Access Compliance Report

Public Rights-of-Way

(Curb Ramps)

Intersection ID: N/A	Main Street: EASTWAY_DR	Cross Street: N/A	Location: SE
ADA ID: 57B1ED097339	Ramp Type: BlendTrans1	Initial Pass/Fail: Fail	Overall Compliance: No
			Severity Score: 36.25

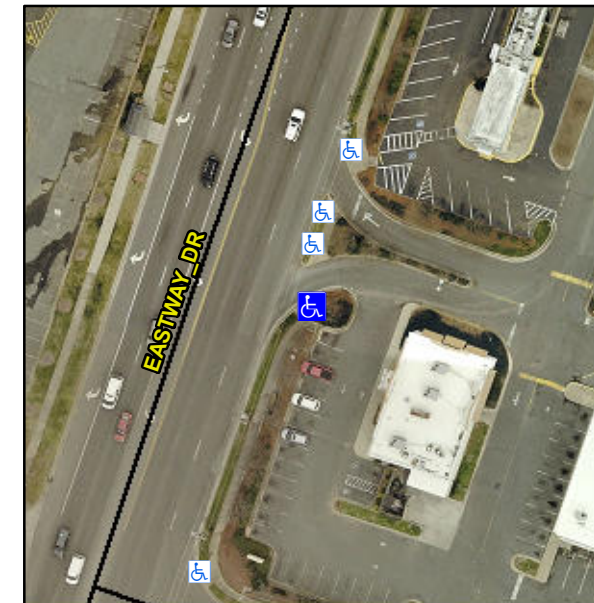
Not Found, R304.5.1, R304.5.3, R302.7

Compliance	Description	Data	Compliance	Description	Data
N/A	Ramp Length (in)	60.0	Yes	BlendTrans Slope (%)	4.9
No	Ramp Width (in)	38.5	No	BlendTrans XSlope (%)	5.4
N/A	Flare Type LT	N/A	N/A	Flare Type RT	N/A
N/A	Flare Slope LT (%)	N/A	N/A	Flare Slope RT (%)	N/A
N/A	Flare Traversable LT?	N/A	N/A	Flare Traversable RT?	N/A
N/A	Landing Length (in)	N/A	N/A	DWS Provided?	N/A
N/A	Landing Width (in)	N/A	N/A	DWS Contrast?	N/A
N/A	Landing Slope (%)	N/A	N/A	DWS Length (in)	N/A
N/A	Landing X Slope (%)	N/A	N/A	DWS Full Width?	N/A
N/A	Landing Curb? (Y/N)	N/A	N/A	DWS Offset (in)	N/A
N/A	Shared Landing?	N/A			
N/A	Gutter Ponding?	N/A	N/A	Gutter Slope (%)	N/A
N/A	Gutter Lip Ht (in)	N/A	N/A	Gutter X Slope (%)	N/A
N/A	Painted X Walk1?	No	N/A	Painted X Walk2?	No
	X Walk 1 Direction	To N		X Walk 2 Direction	To W
	X Walk 1 Width (in)	N/A		X Walk 2 Width (in)	N/A
	X Walk 1 Slope (%)	4.1		X Walk 2 Slope (%)	1.9
	X Walk 1 X Slope (%)	2.3		X Walk 2 X Slope (%)	3.4

N/A	Ramp inside XWalk1?	N/A	N/A	Ramp inside XWalk2?	N/A
	Road Slope (%)	4.0		Clear Space?	N/A
	Road X Slope (%)	0.6	N/A	Clear Space to XWalk (in)	N/A
N/A	Any Obstructions?	N/A	N/A	Storm Grate/Utility Hazard?	N/A
	Obstruction Type			Storm Grate/Utility Type	
		N/A			N/A
			No	Surface Condition? (G/P)	Poor
			No	Curb Slope (%)	16.2

Remove & Replace Curb Ramp With Two New Directional Ramps or Equivalent.
